DEVELOPMENT REVIEW BOARD REPORT

SUBJECT	Scottsdale Estates 13-PP-2005
REQUEST	<p>Request approval of a Preliminary Plat for an 11-Lot development on a 6+/- acre parcel.</p> <p>Related Policies, References: Case 8-ZN-2005 rezoned the property from the R1-35 District to the R1-18 PRD District to allow this subdivision.</p>
OWNER	Earlie Homes 602-954-9525
APPLICANT CONTACT	David Brantner Earlie Homes 602-954-9525
LOCATION	Northeast corner of E. Cactus Road and N. 90 th Street.
BACKGROUND	<p>Zoning. The site was rezoned from Single Family Residential District (R1-35) to Single Family Residential, Planned Residential Development District (R1-18 PRD) in August 2005. The rezoning case was stipulated to a specific site plan with amended development standards that allow a reduction of the lot sizes, widths, and setbacks. The result of modified lot widths and setbacks allows opportunities for landscaped buffers along E. Cactus Road and N. 90th Street, and open space tracts at the entrance of the property and at the E. Cactus Road/N. 90th Street intersection (see Attachment #7). In addition, the applicant has agreed to limit all homes to one story.</p> <p>Context. The property consists of 6.

SCOTTSDALE ESTATES PRELIMINARY PLAT

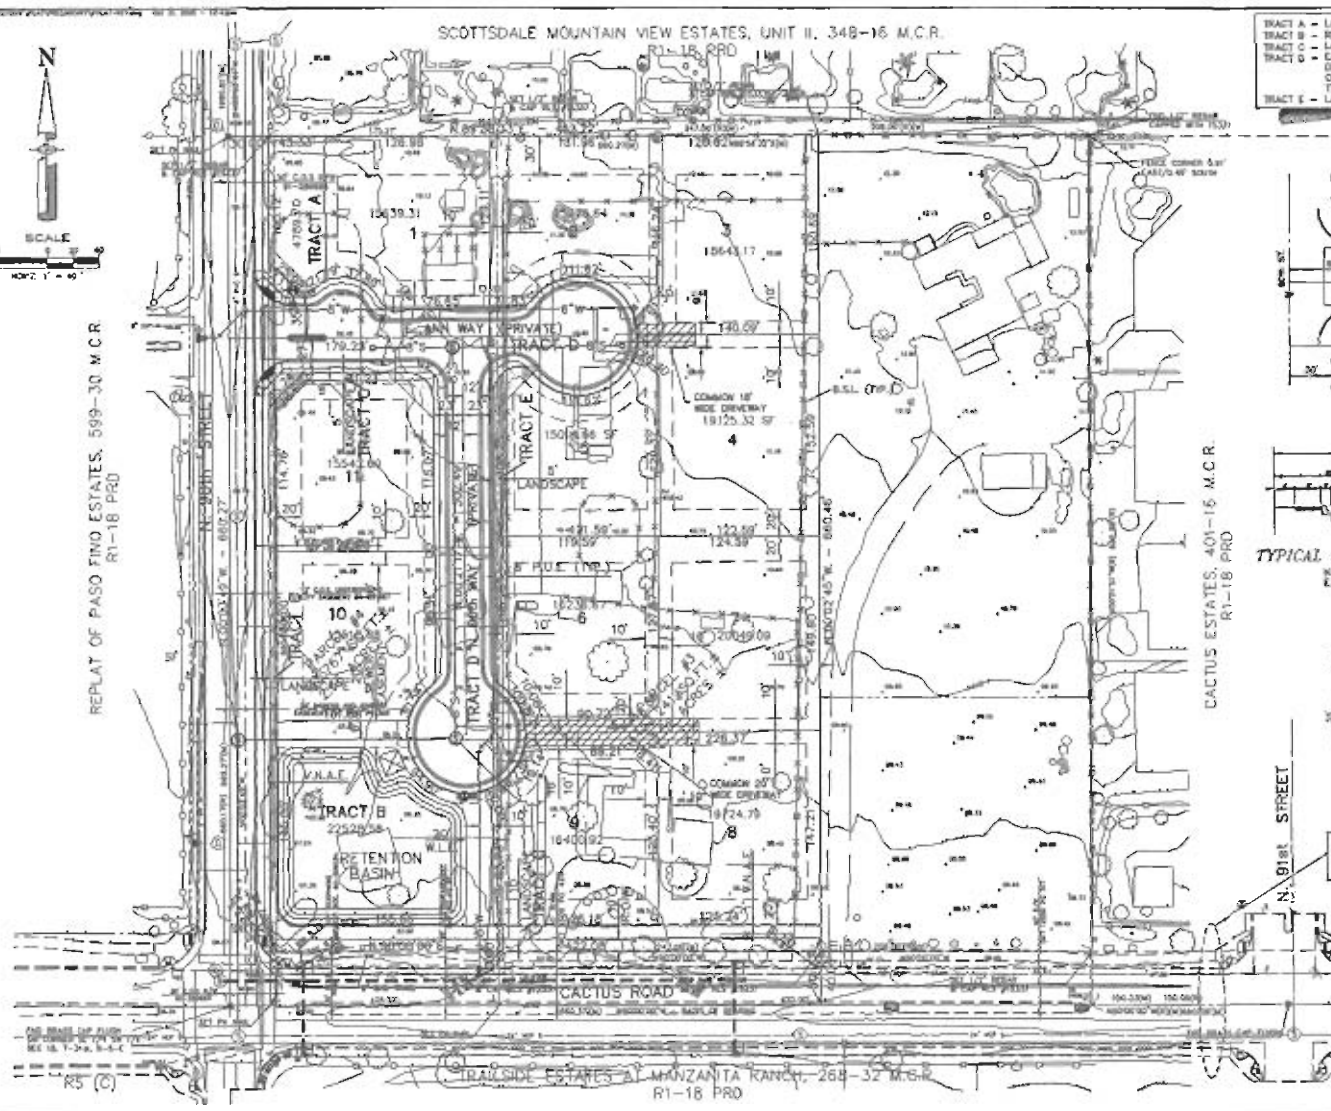
3. *At time of final plans submittal the Preliminary Plat shall be revised to remove setbacks, existing conditions, topography elevations and the parcel to the east.*

4. *At time of final plans, the common driveway shall be twenty (20) feet in width to match the flag lot width.*
5. *Prior to final plans approval all existing structures shall be demolished.*

Conceptual Hardscape Details

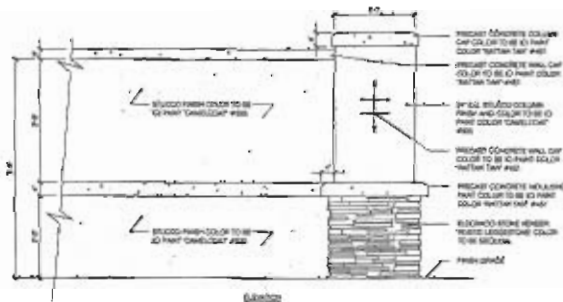
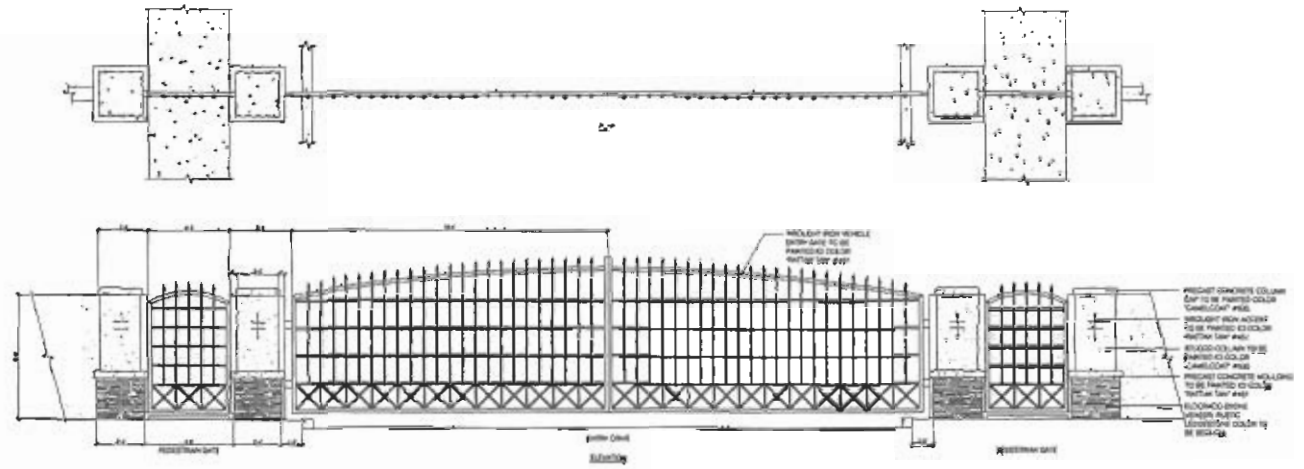
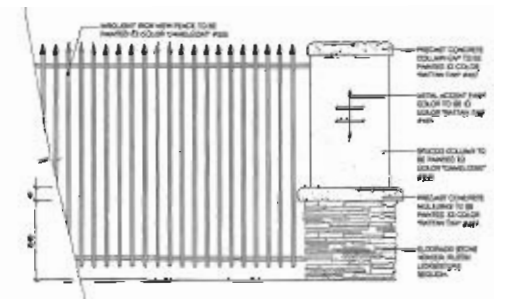
12. *All walls shall match the architectural color, materials and finish of Conceptual Hardscape Details plan provided by Cleland-Group dated 10/31/05 by City staff.*
13. *The perimeter wall located at the southeast corner of Lot 8 shall be cut at an angle to allow greater visibility for vehicles existing the parcel to the east. The developer should consider adding the area outside the perimeter wall to the proposed Tract C.*
14. *Walls within a sight visibility triangle shall not exceed 2'-0" measured from nearest street line as described in the DS&PM.*
